**SPECIAL MAINTENANCE INSTRUCTIONS NO. RDSO/ELRS/SMI/146**

**Breakage of Journal pin of SMGR Tap Changer No. 32 - ABB Make**

**Modification Sheet No. RDSO/ELRS/MS/0292-2000 (REV-0)**

**Title : GR progression and regression valve emergency operation circuit  
modification in microprocessor based WAG-7 locomotive.**

HBB Drawing NO.SWT 435429 (Enclosed as Annexure 2)

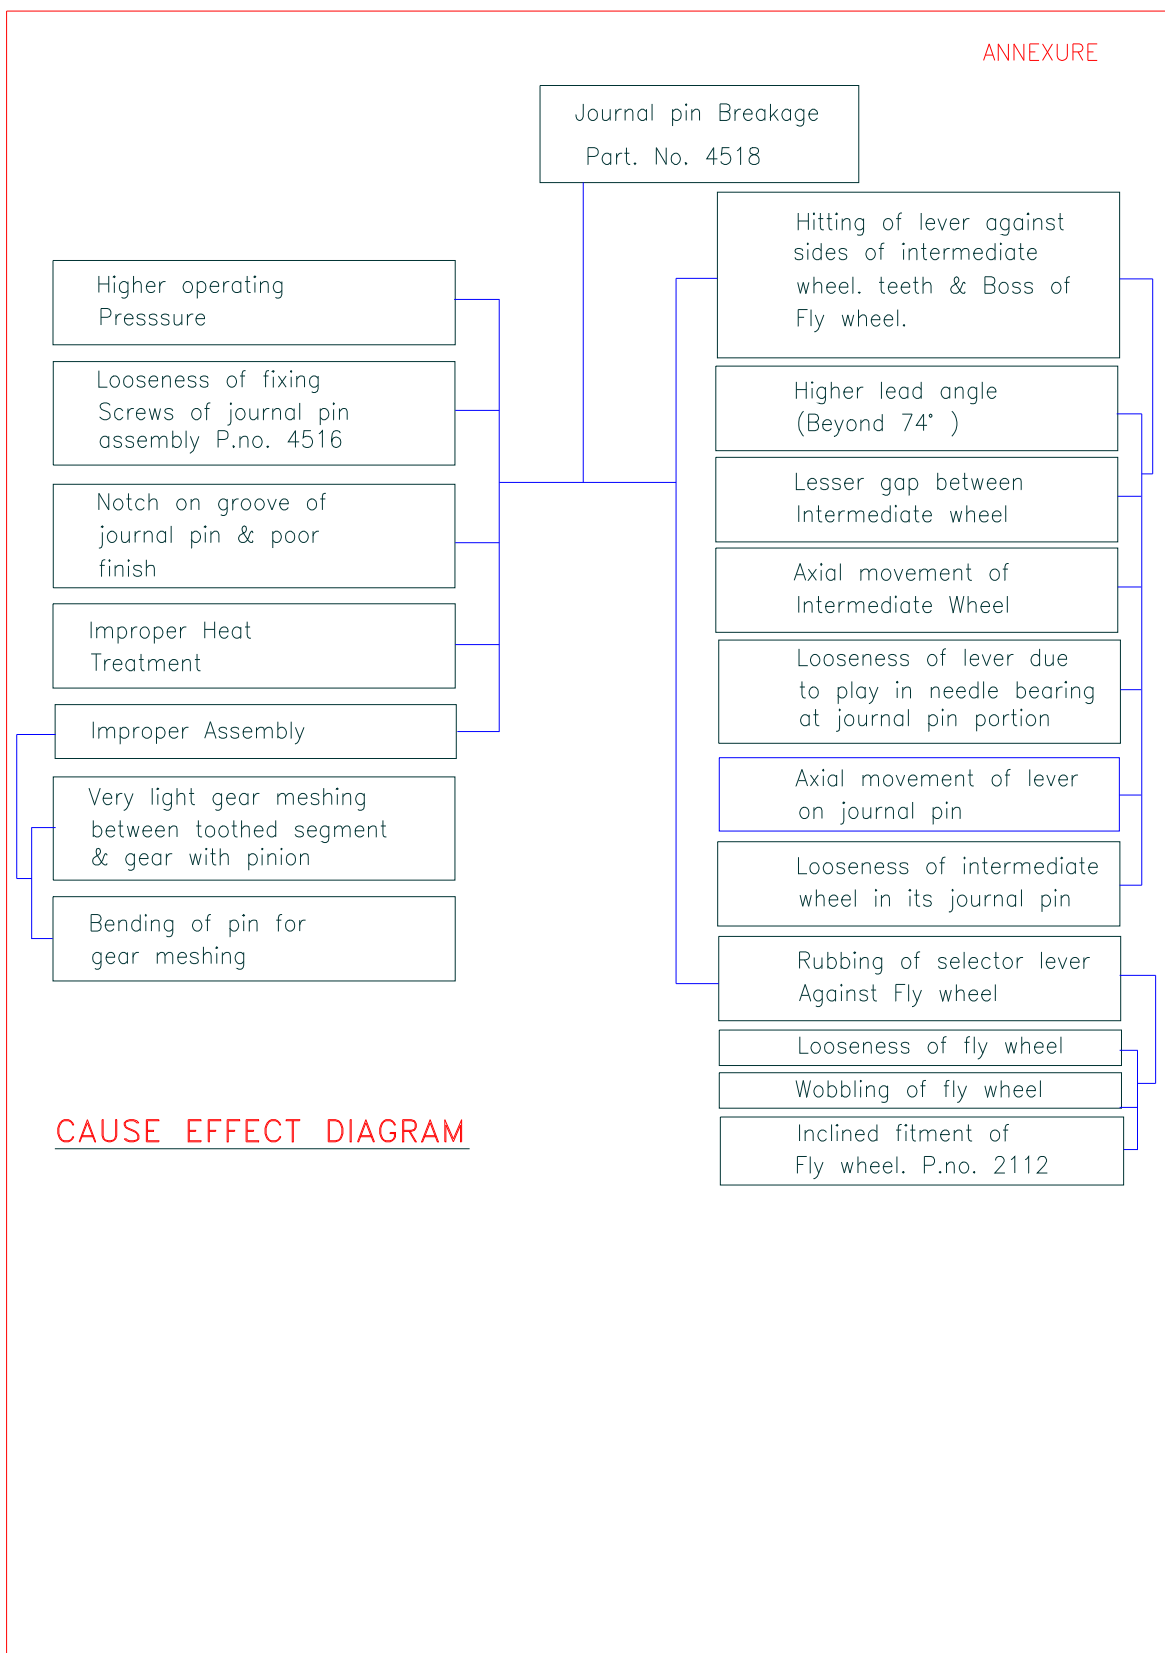
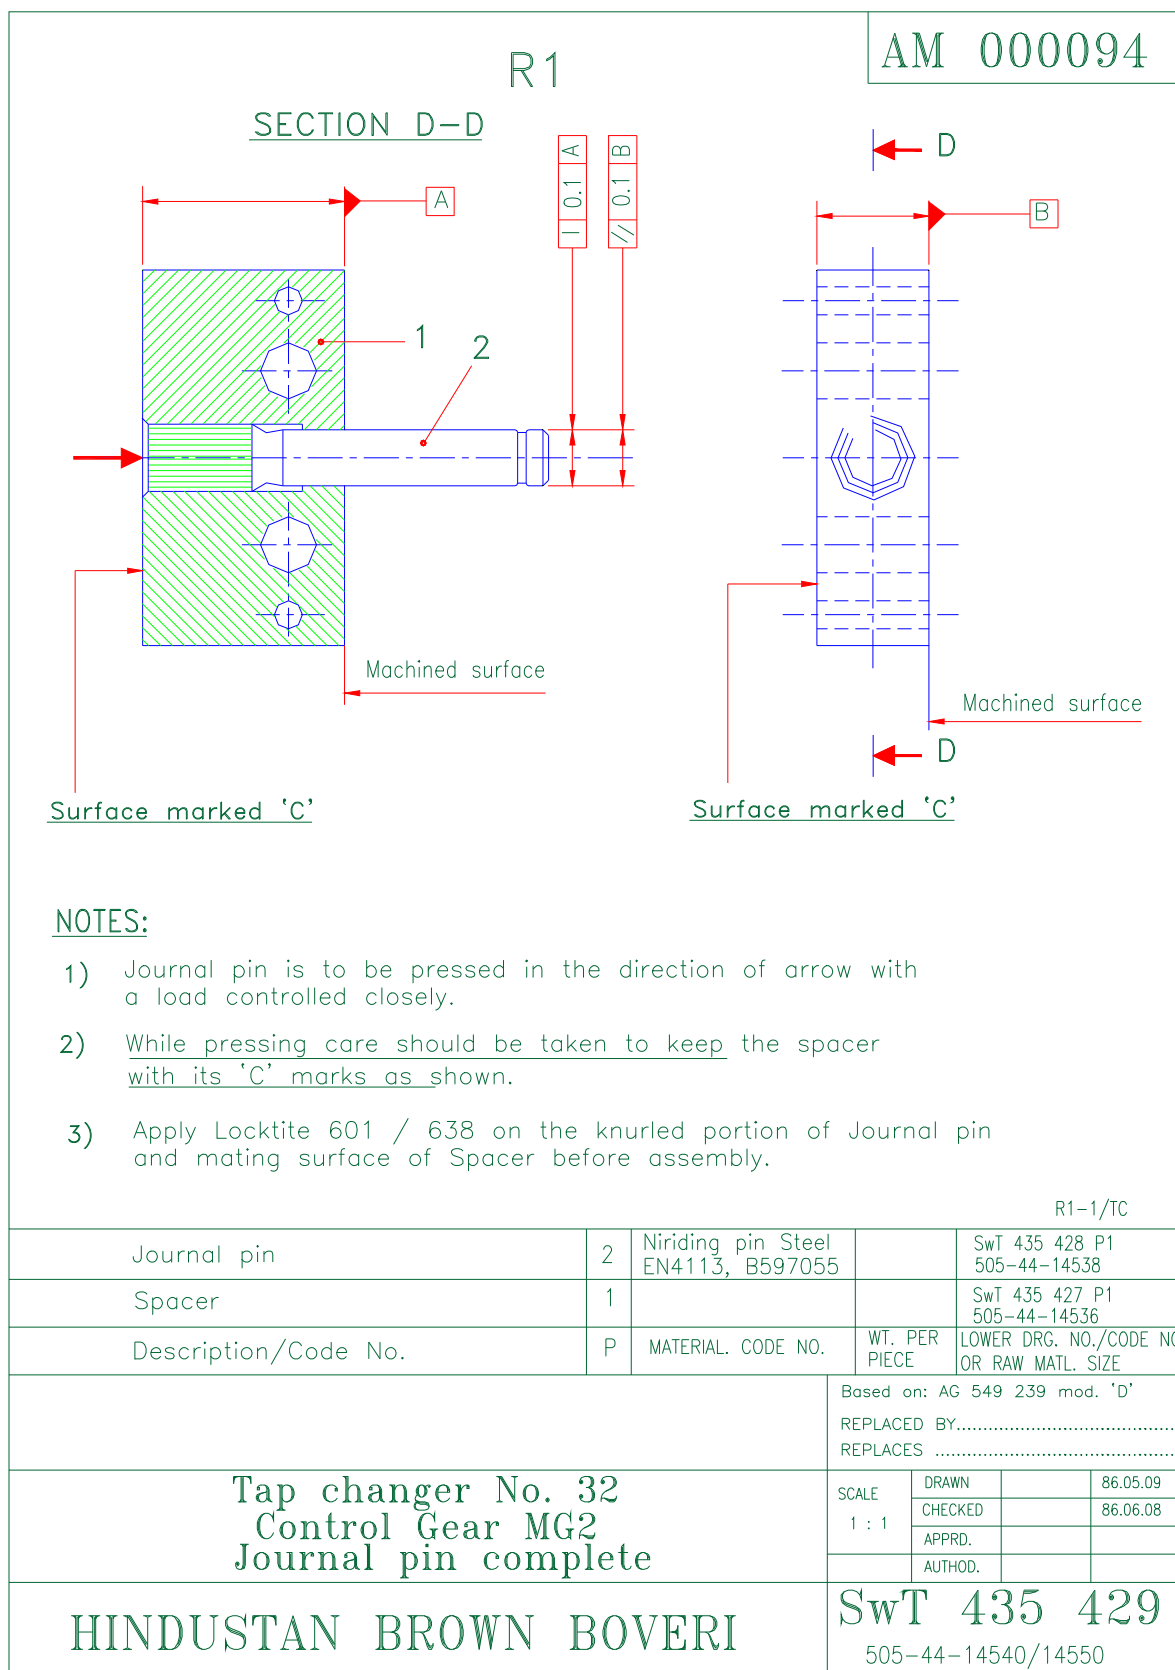
Railways have reported cases of breakage of journal pin of SMGR. The probable reasons and remedial measures to overcome these failures are listed in the following enclosed instructions for compliance.

- a. Cause effect diagram (Ref. Annexure-1)
- b. Journal pin modification (Ref. Annexure-2)
- c. Check sheet for failure of journal pin (Ref. Annexure-3)
